**U.S. Department of Energy**  
**Office of River Protection**

06-WED-009

CONTRACT NO. DE-AC27-01RV14136 – TRANSMITTAL OF WASTE TREATMENT AND IMMOBILIZATION PLANT (WTP) OPERATIONS RESEARCH, TANK UTILIZATION, AND STEADY STATE FLOWSHEET ASSESSMENT DESIGN OVERSIGHT REPORT (D-05-DESIGN-021)

**Figure 2.1 Current Status of Reconciliation of the R&T Reports for the WTP Process Models.**

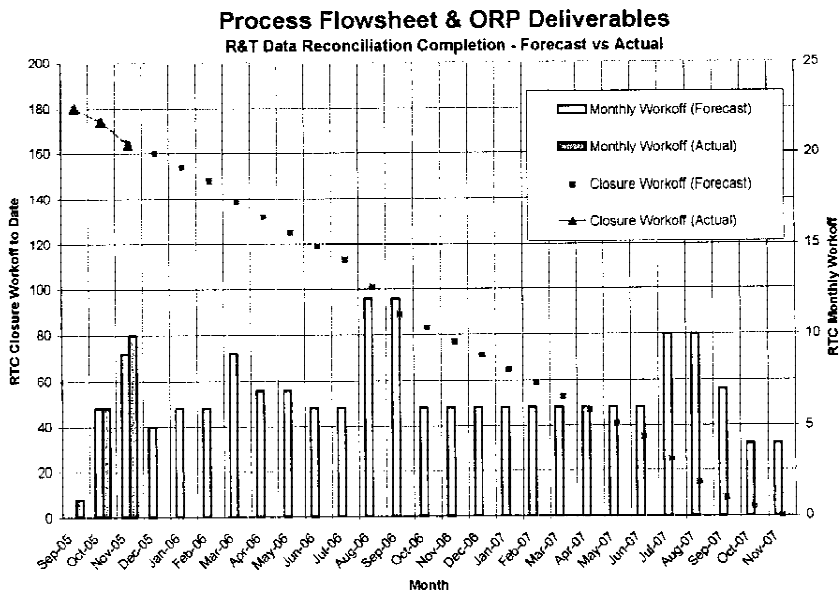
Shown in Figure 2.1 is the current status of the data reconciliation effort. Based on discussions with BNI, over 150 reports are issued that have not been reviewed for reconciliation. Completion of the reconciliation process is projected to extend through 2007. BNI also stated this schedule may be extended as a result of FY 2006 project funding levels. The oversight team considers review of R&T test reports to reconcile the process models and design basis documentation as critical to assuring the WTP design has appropriate technical underpinning.

Completion of review and reconciliation of data in test reports is critical to support the project's objective to provide appropriate separation between design and construction to reduce project risk to more reasonable levels. Information learned from R&T reports has the potential to impact facility equipment design, waste routing, process flowsheet design, and operational performance.

**Figure A.1 Current Status of Reconciliation of the R&T Reports for the WTP Process Models.**

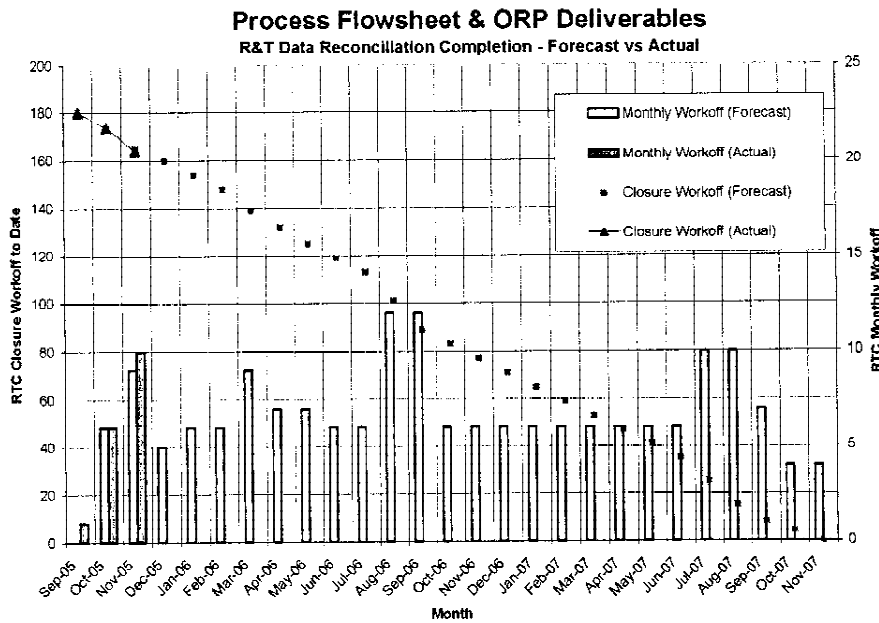
Shown in Figure A.1 is the current status of the data reconciliation effort. Based on discussions with BNI, over 150 reports are issued that have not been reviewed for reconciliation. Completion of the reconciliation process is projected to extend through 2007. BNI also stated this schedule may be extended as a result of FY 2006 project funding levels. The oversight team considers review of R&T test reports to reconcile the process models and design basis documentation as

critical to assuring the WTP design has appropriate technical underpinning. Completion of review and reconciliation of data in test reports is critical to support the project's objective to provide appropriate separation between design and construction to reduce project risk to more reasonable levels. Information learned from R&T reports has the potential to impact facility equipment design, waste routing, process flowsheet design, and operational performance.

**Figure 3-14 TRI Radionuclides in the LAW Glass (TPA Phase 1 Milestone with HLW Melter at 6 MTD)**

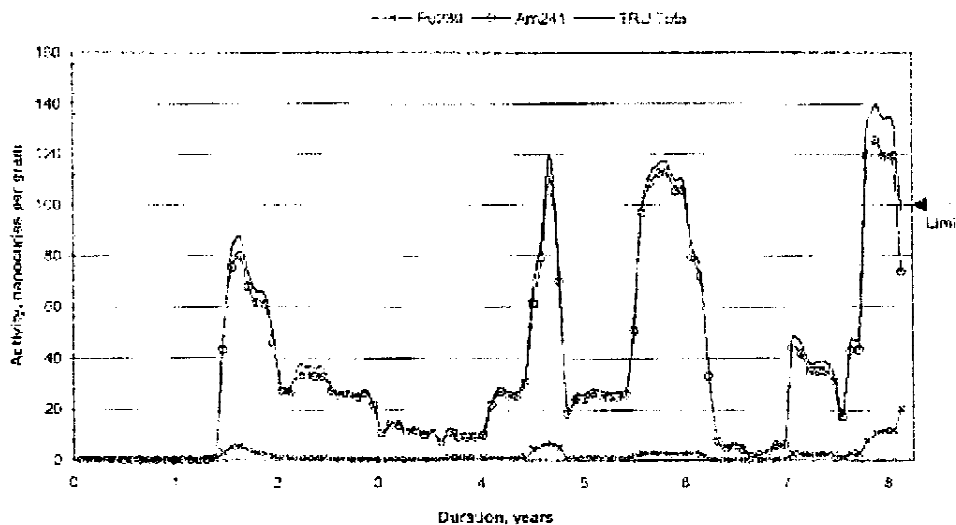
The use of the TWINS transuranic water wash factors results in the Tank Utilization model predicting several batches of ILAW will exceed the 100 $\eta$ Ci/gram transuranic concentration limit, as shown in Figure 3-14, 24590-WPT-RPT-PO-05-008, revision 0.

Figure B-2 Plant Wash Vessel PWD-VSL-00044 Utilization for 2023

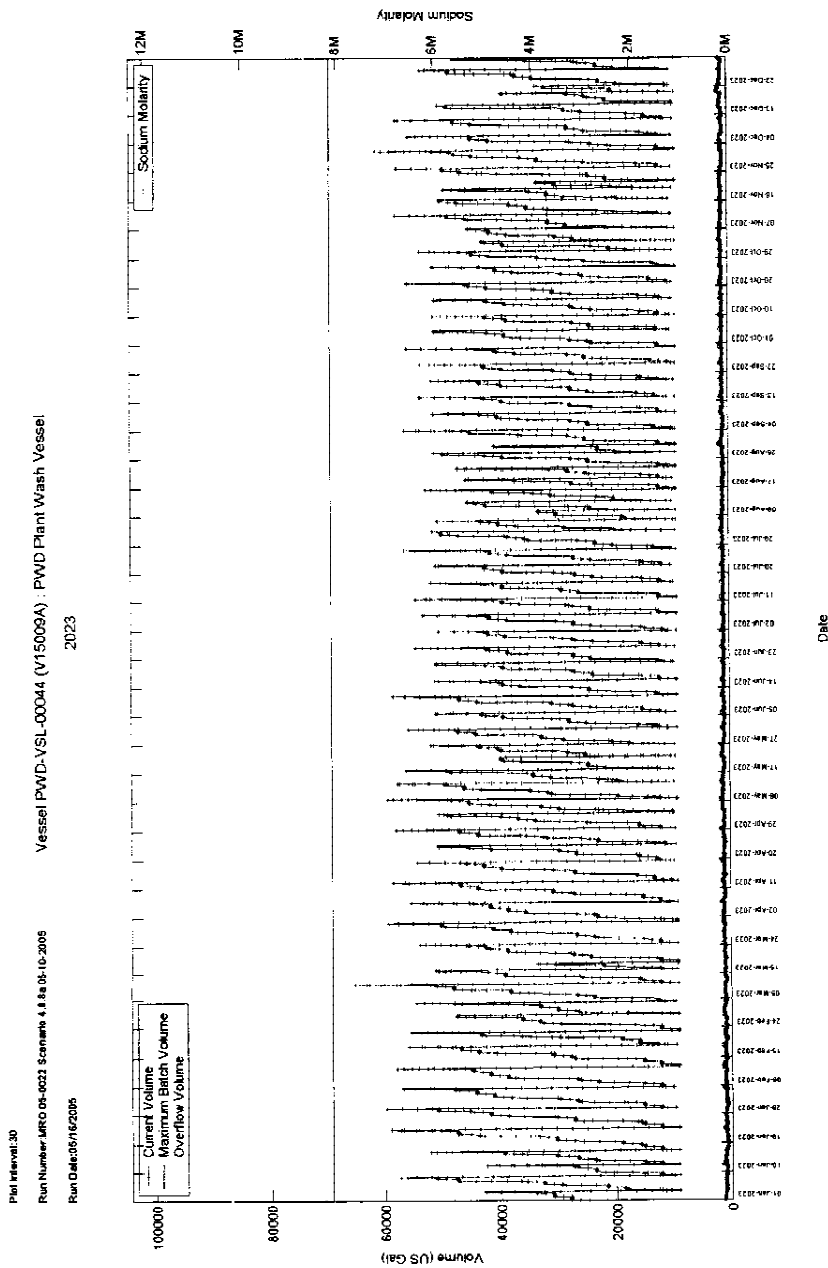
Assuming the hydrogen mitigation strategy for pipes and ancillary vessels results in increases in flush volumes, the plant wash vessel (PWD-VSL-00044) would be used to collect additional flush volume before processing in the feed evaporator process (FEP) system. BNI has assessed the utilization of the plant wash vessel PWD-VSL-00044 during sequential alkaline and oxidative leaching run conditions for the mission duration (24590-WTP-MRR-PO-05-006, scenario 4.0.8a). The batch volume of waste solution in plant wash vessel PWD-VSL-00044 varies from minimum heel to a maximum of ~65,300-gallons (March 10, 2023), which is ~94% of the maximum batch volume (69,166-gallons) allowable in this vessel. The batch volume of

waste solution in plant wash vessel PWD-VSL-00044 is frequently in excess of 80% of the maximum batch volume (Refer to Appendix B, Figure B.1).

maximum batch volume, as shown in Figure B-2.
